I have the honor to forward duly approved an estimate for Rs 2592/- for flooring the verandah around the Banqueting Hall, Madras, with compressed tiles in connection with the verandah now in course of construction.

Submitting explanation
of the necessity for the work
flooring the verandah
round the Banqueting
hall with pressed tiles &c

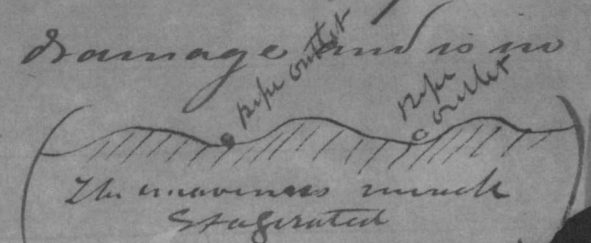
Referred to the Consulting Architect for full explanation of the necessity for the three items of work proposed. It is not clear why compressed tiles should be substituted for the existing cement flooring. The report submitted is very meagre.

In reply to your No. 3477 C dated the 14th Instant, I have the honor to inform you that when the Estimate was submitted for the construction of the Serandah to the Banquetting Hall, it was not intended to alter what was then the roof of the basement though it would become the floor of the new Serandah, because it had frequently been used as a promenade to the portions covered in by an awning, the inconvenience now found to be inconvenient had not been taken exception to. This former roof now floor, had been constructed unevenly in order to facilitate the drainage and so in the shape indicated thus

This only applies to the two sides, the ends at the entrances are level and need not be altered but it was proposed to lay the whole of the verandah with pressed tiles for the sake of uniformity and to use tiles rather than cement for the sake of greater durability. I have however since thought that if the East & West verandahs only are altered it might suffice & to do the work with cement, as when they are used these floors will nearly always be covered with carpets, and the North & South verandahs may remain unaltered. If this be sanctioned no additional allotment need be made as there is sufficient saving in the original estimate to cover the cost.

The relaying with cement
of the East and West verandah
floors may be charged to
repairs, and the cost of the
step ladder and the
extra door may be met from
savings in the original estimate.
